# Metropolitan Development Commission Plat Committee (September 13, 2023) Meeting Agenda

**PLAT COMMITTEE****September 13, 2023**

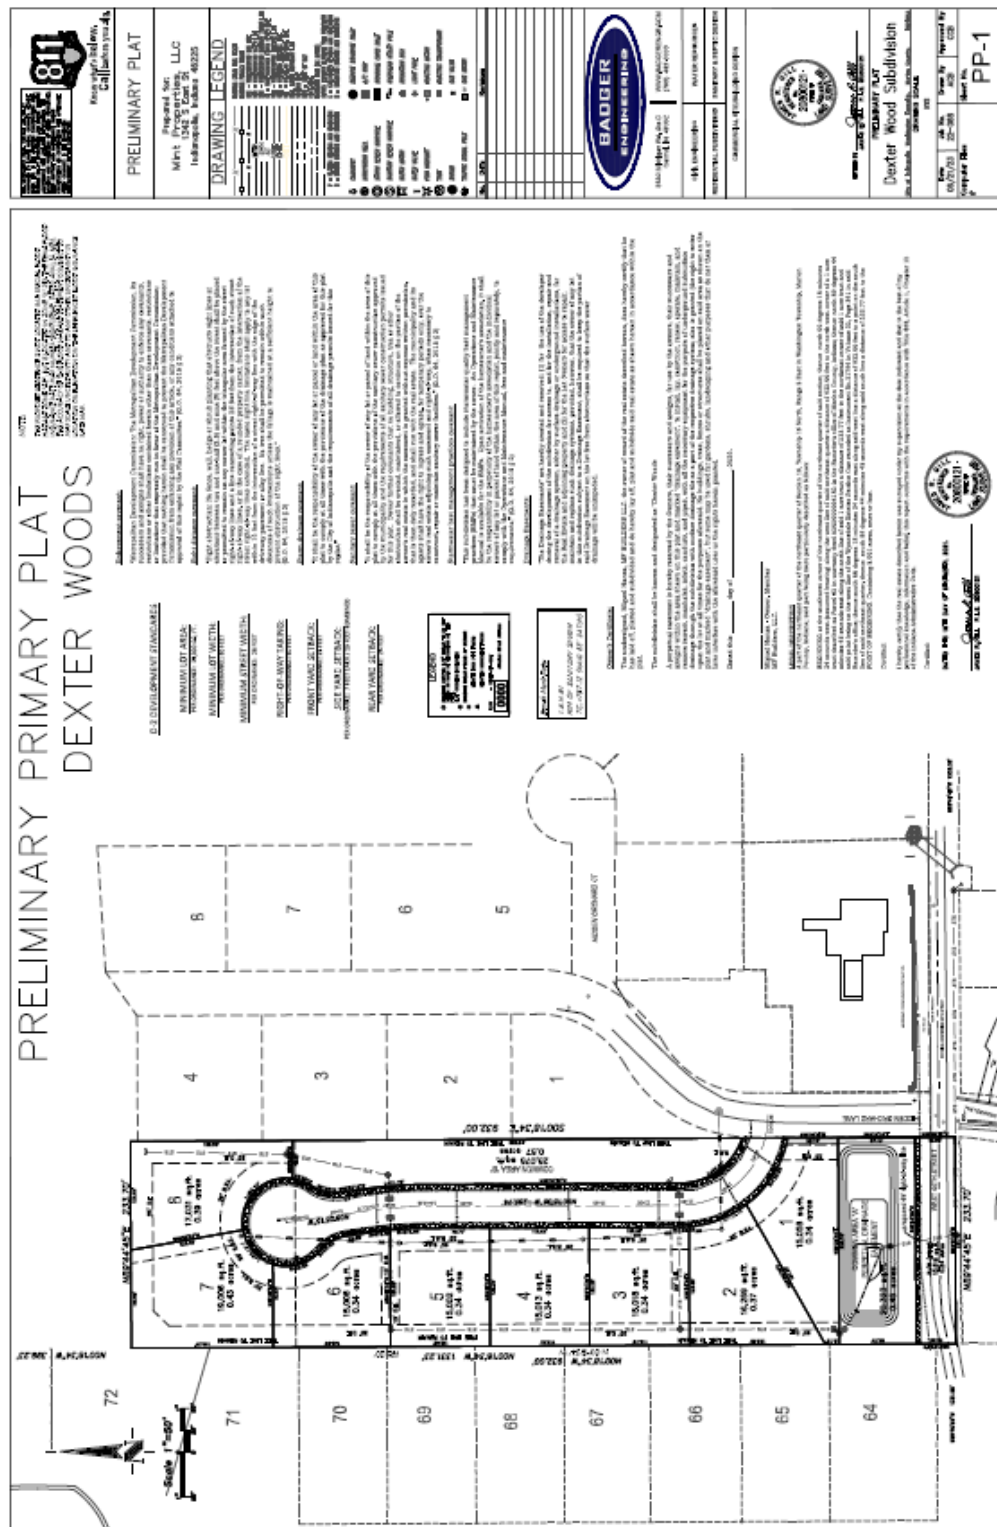
The proposed cul-de-sac exceeds the maximum 500-foot length permitted; however, given that a cul-de-sac may serve up to 20 lots and only eight lots are proposed, staff believes this is a reasonable request and is not opposed to the waiver.

Additionally, the cul-de-sac length waiver was previously approved by the Plat Committee in 2020.

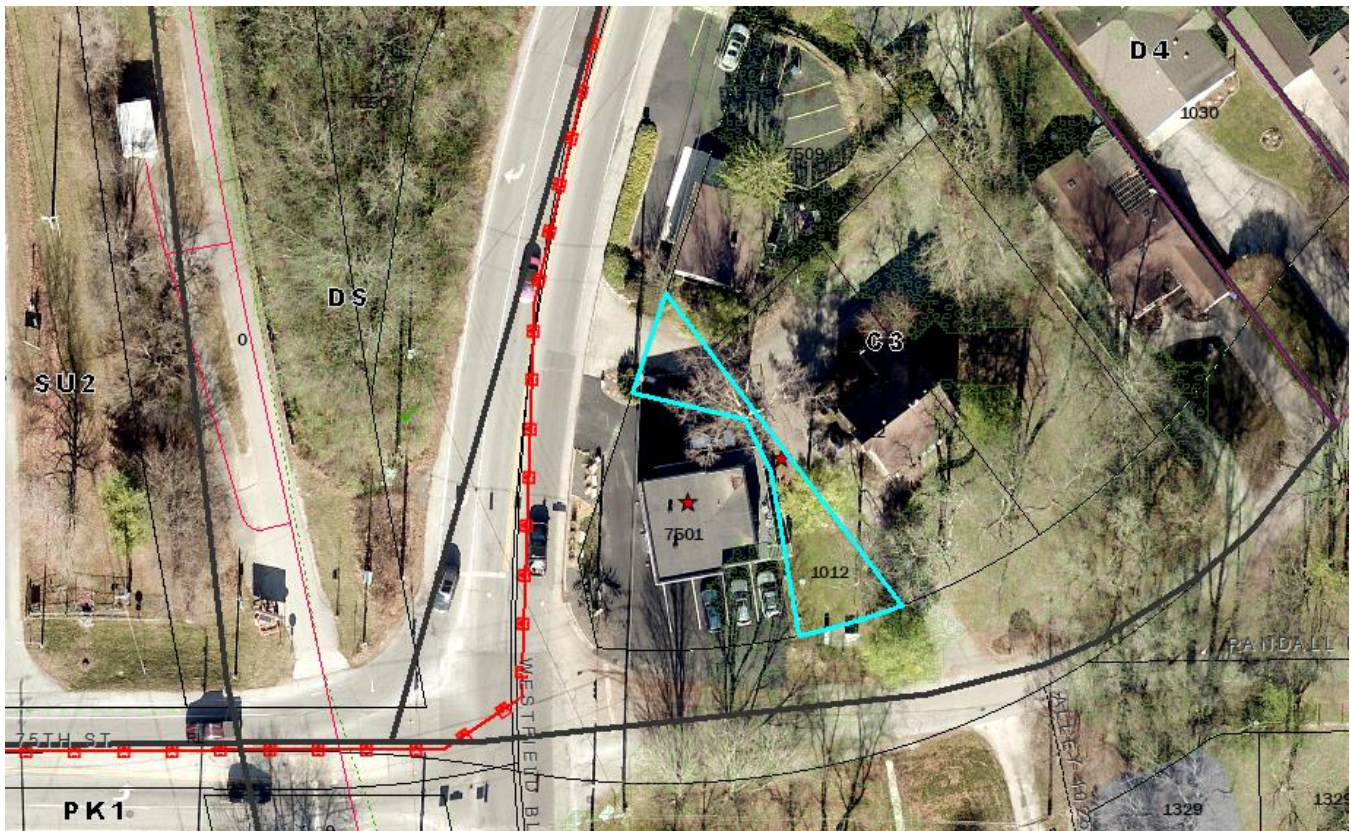
The right-of-way on Westfield Boulevard is developed in a way that installing sidewalks would interfere with existing utilities for the traffic signal. Staff would also note that the Monon Trail is on the opposite frontage on Westfield Boulevard, so it is unlikely that any sidewalks on the subject site would be useful. There is adequate room on East 75<sup>th</sup> Street for sidewalks, however, since there are no proper landings, walk signals, or other pedestrian amenities at the intersection, the Department of Public Works and staff would support a waiver of sidewalks.

Staff is recommending that a contribution to the sidewalk fund, in lieu of installing sidewalks, be required as a condition of the approval of this waiver.
